UNC Workgroup Report	At what stage is this document in the process?
<h1>UNC 0712S:</h1> <h2>Amending the oxygen content limit in the Network Entry Agreement (NEA) at the St Fergus SAGE plant</h2>	<div style="display: flex; flex-direction: column; gap: 5px;"> <div style="border: 1px solid #ccc; padding: 2px; display: flex; align-items: center; gap: 5px;"> 01 Modification </div> <div style="border: 1px solid #ccc; padding: 2px; display: flex; align-items: center; gap: 5px;"> 02 Workgroup Report </div> <div style="border: 1px solid #ccc; padding: 2px; display: flex; align-items: center; gap: 5px;"> 03 Draft Modification Report </div> <div style="border: 1px solid #ccc; padding: 2px; display: flex; align-items: center; gap: 5px;"> 04 Final Modification Report </div> </div>
<p>Purpose of Modification:</p> <p>This enabling Modification will facilitate an increase to the current oxygen content limit at the St Fergus SAGE System Entry Point through modification of the SAGE Network Entry Agreement / Provision</p>

<p>The Workgroup recommends that this modification should be subject to self-governance</p> <p>The Panel will consider this Workgroup Report on 20 February 2020. The Panel will co

Heat Maps: Gas Year 2019/20

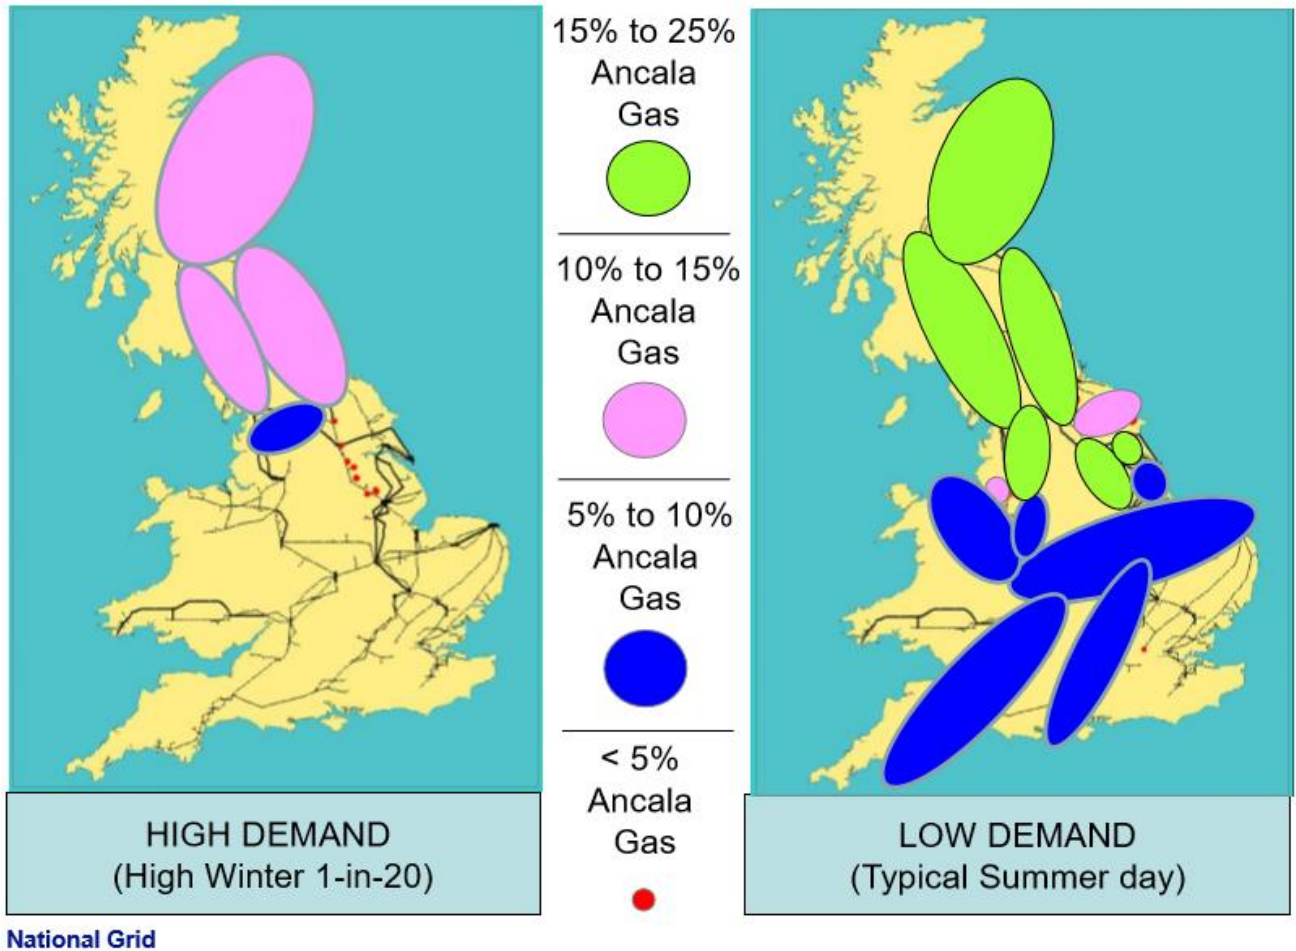
In order to better understand the extent to which this particular stream of gas could vary gas composition across GB, the Workgroup asked National Grid to produce appropriate analysis showing penetration of St Fergus SAGE gas across the NTS. National Grid produced four ‘heat maps’, (two for a summer day (low) flows and two for a winter day (peak) flows), which show the degree of penetration of St Fergus SAGE gas into the NTS based on the latest Future Energy Scenarios (FES) data. A similar approach was adopted for a previous modification proposal to vary the oxygen content at South Hook, (Proposal 645, linked above in Section 4).

The full presented analysis may be found here: [Ancala Oxygen Penetration Modelling](#), but as an informational highlight, the analysis that showed the greatest penetration was the map for the current year, shown below. FES modelling suggests that the penetration for gas years 2025/26 and 2030/31 would reach less of GB than the current year flow-pattern scenario.

This flow scenario results in a comingled stream of gas in the NG terminal of

- ~15ppm oxygen (peak case); and
- ~25ppm oxygen (low demand case)

would enter the NTS pipelines at St Fergus.
